National Committee on Uniform Traffic Control Devices

National Committee on Uniform Traffic Control Devices (NCUTCD) Recommended Changes to Proposed Text for 11th Edition of the MUTCD Docket Number: FHWA-2020-0001

NPA MUTCD Section Number: Sections 2C.01-2C.72

Figure 2C-6. Example of Signing at Narrow or One-Lane Underpass or One-Lane Bridge.

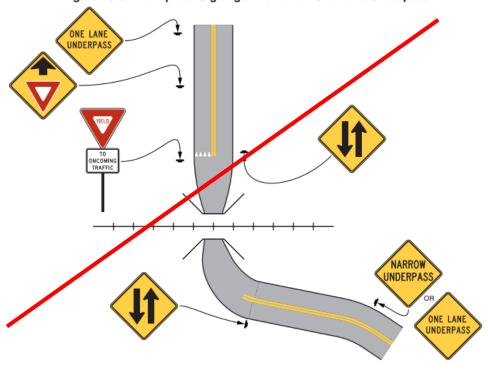
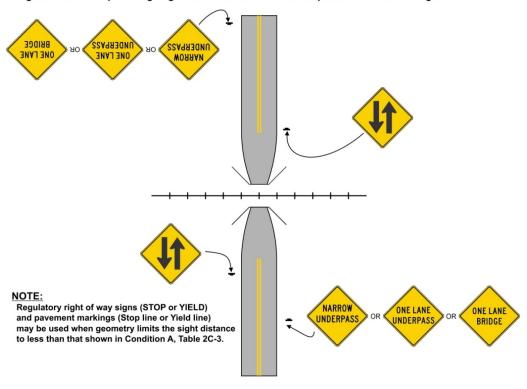
NCUTCD recommends deleting Figure 2C-6 as presented in the NPA and substituting a new Figure 2C-6 to provide for all likely situations and options at narrow or one-lane underpasses, and adds a note suggesting the use of STOP or YIELD signs or a combination thereof based on relative sight distance available to approaching traffic where there are sight restrictions that suggest a need for these signs. To address this, the figure recommended by NCUTCD depicts a

straight roadway approach without a curve.

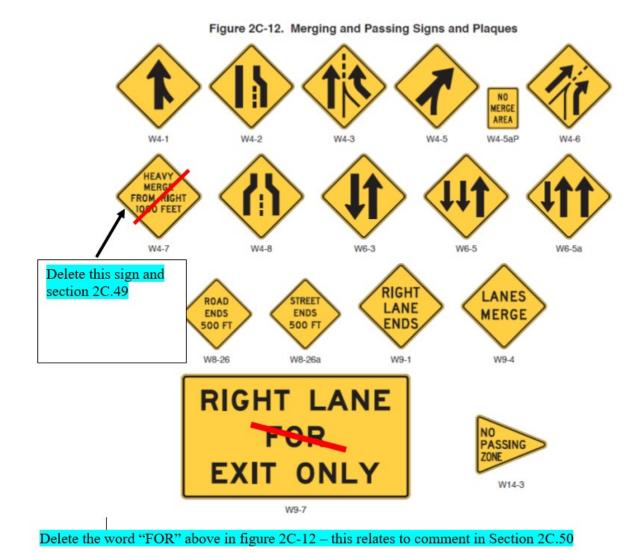
NCUTCD generally agrees with Figure 2C-12 as presented in the NPA, but recommends the following revisions:

Figure 2C-13. Example Sequences for Lane Ends and Lane Merge Signs Freeways / Expressways (Sheet 1 of 5)

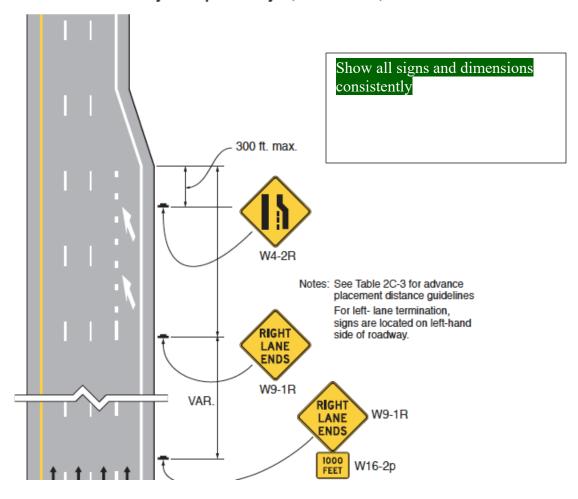
1591 1592 NCUTCD generally agrees with Figure 2C-13 sheet 1 of 5 as presented in the NPA, but recommends showing all signs and dimensions consistently with other Figures in other chapters of the MUTCD related to lane ends signing and markings.

Figure 2C-13. Example Sequences for Lane Ends and Lane Merge Signs Conventional Roads (Sheet 2 of 5)

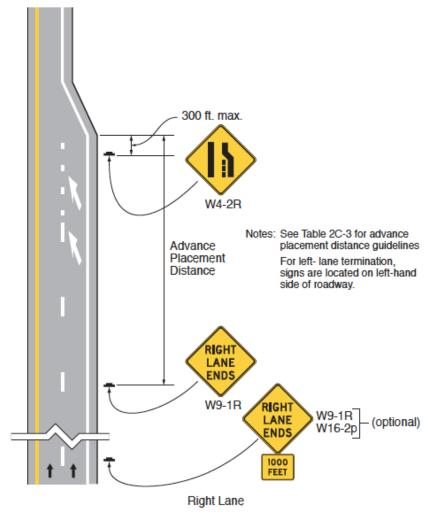
NCUTCD generally agrees with Figure 2C-13 sheet 2 of 5 as presented in the NPA, but recommends showing all signs and dimensions consistently with other Figures in other chapters of the MUTCD related to lane ends signing and markings.

Figure 2C-13. Example Sequences for Lane Ends and Lane Merge Signs Conventional Roads (Sheet 3 of 5)

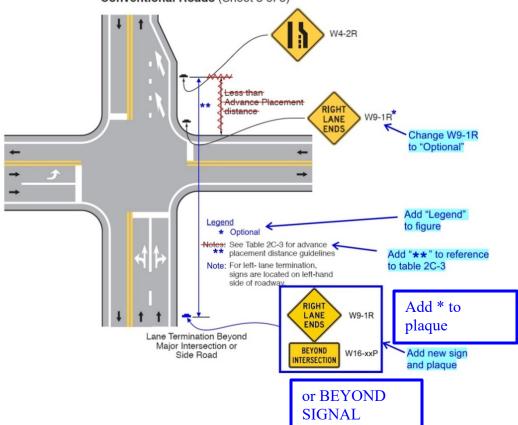
1605 1606 1607 NCUTCD recommends revising Figure 2C-13 sheet 3 of 5 as presented in the NPA as follows:

- Add a W9-1R and BEYOND INTERSECTION or BEYOND SIGNAL plaque assembly upstream of the intersection with a distance determined by Table 2C-3
- Change the W9-1R immediately downstream of the intersection to optional
- Other editorial revisions as needed

Figure 2C-15. Vehicular Traffic Warning Signs and Plaques

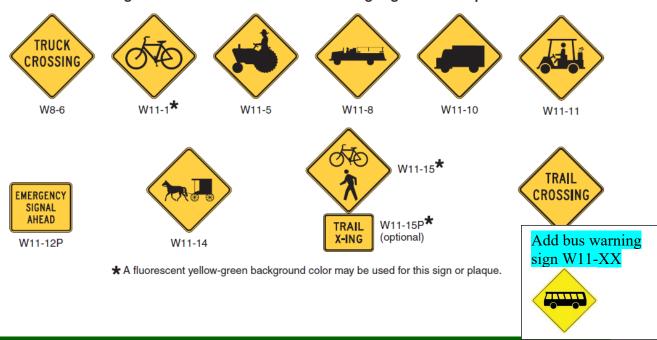
NCUTCD generally agrees with Figure 2C-15 as presented in the NPA, but recommends adding a W11-XX Bus warning sign in accordance with NCUTCD recommendation 20B-RW-02. FHWA may want to consider also adding a BUS supplemental plaque that could be used with the Bus warning sign.

Figure 2C-17. Supplemental Warning Plaques

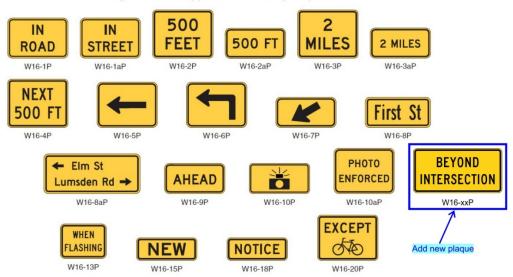
1992 1993 NCUTCD generally agrees with Figure 2C-17 as presented in the NPA, but recommends adding new BEYOND INTERSECTION and BEYOND SIGNAL plaques. FHWA may want to consider also adding a BUS supplemental plaque that could be used with the Bus warning sign.
